P802.3bq D2.3 & P802.3bz D1.1 Comments for ad hoc Review

IEEE P802.3bz ENUCA and P802.3bq RxCMNR ad
hoc

IEEE P802.3bq D2.3 25G/40GBASE-T Ethernet 3rd Working Group recirculation ballot comments

IEEE P802.3bz D1.1 2.5G/5GBASE-T 2nd Task Force review comments

Figure 113A–2—Cross-section of cable clamp

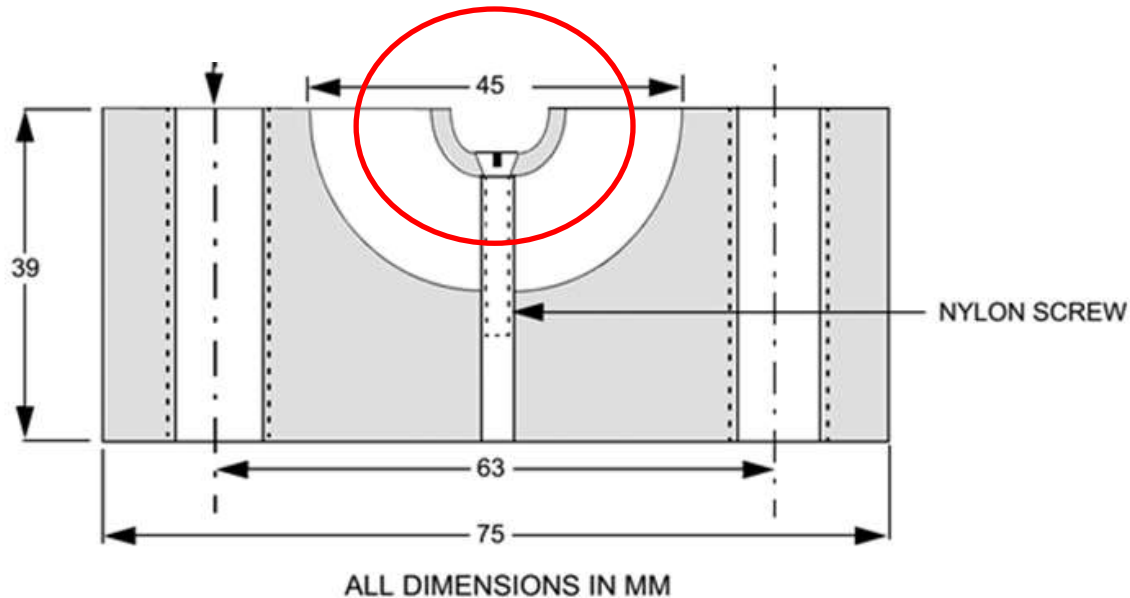
113A	113A.2	221	43	E	As shown in Figure 113A–2 the inner conductor on the bottom half of the clamp extends slightly (~ 0.1mm) - this is not shown in the figure	Delete "As shown in Figure 113A-2", capitalize "the"
113A.3	113A.3	222	20	E	This sentence gives me the impression that it implies the documented test is normative (not just doubly equivalent). It is also not clear what it is referring to; the entire procedure, the measurement or the validation. Note that other measurement methods are allowed providing they can demonstrate equivalent equivalent results to the method described in this Annex.	delete or figure a good way to move the repaired statement into the overview 113A.1
113A.3	113A.3	223	7	E	indentations not matching	dent
113A.3	113A.3	223	30	E	should be plural - two are shown	change to Oscilloscopes, power meters or spectrum analyzers
113A.3	113A.3	224	10	E	duplicate statement two sentences above (and incorrect as stated)	delete The cable between the clamp and the balun should be straight and not in contact with the ground plane.

- Comment #57 - As shown in Figure 113A–2 the inner conductor on the bottom half of the clamp extends slightly (~ 0.1mm) - this is not shown in the figure
- Suggested Remedy - Delete "As shown in Figure 113A-2", capitalize "the“

Proposed Accept

Note – A similar discrepancy exists in Annex 40B, Figure 40B-2

Figure 113A-3—Cable clamp validation test configuration

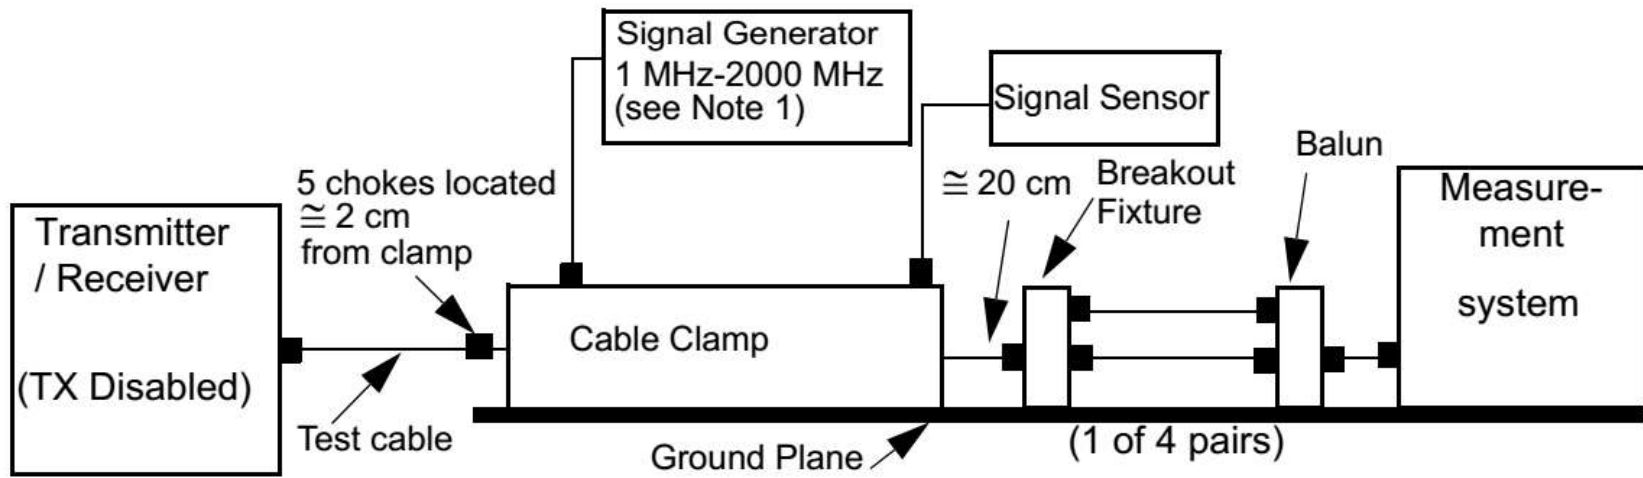
- Comment #TBA - should be plural - two are shown
 - Suggested Remedy - change to Oscilloscopes, power meters or spectrum analyzers
 - Since the measurements could be performed sequentially, suggest keeping text as-is. The text does not preclude using more instruments.
- i) Signal Sensor & Measurement System - Oscilloscope, power meter or spectrum analyzer with at least 4000 MHz bandwidth

- Comment #87 - duplicate statement two sentences above (and incorrect as stated)
- Suggested Remedy - delete The cable between the clamp and the balun should be straight and not in contact with the ground plane.
- Alternative remedy – Change to “Cables between the breakout fixture and the balun should be straight and not in contact with the ground plane.

Proposed Accept in Principle (see suggested text)

Figure 113A-4—Cable clamp test configuration

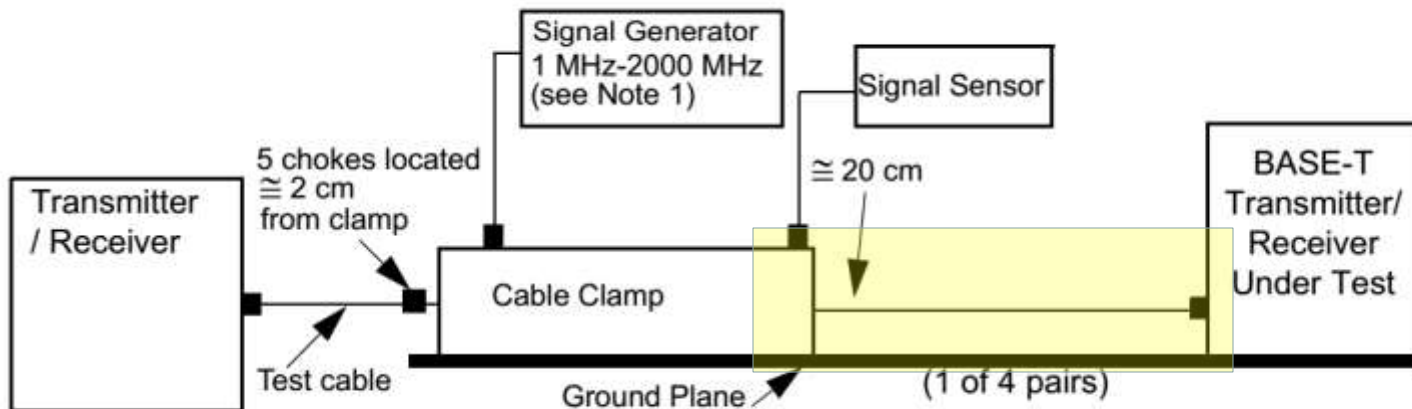
It would be better to see this image redrawn so it does not appear that the cable was pulled out an extra length from its original validation position.

- Comment #90 - It would be better to see this image redrawn so it does not appear that the cable was pulled out an extra length from its original validation position.
- Suggested Remedy– as suggested
- Both figures define the length; the figures are consistent with Clause 40. Suggest not changing.

Proposed Response Response Status W
PROPOSED REJECT.

Proposed Reject
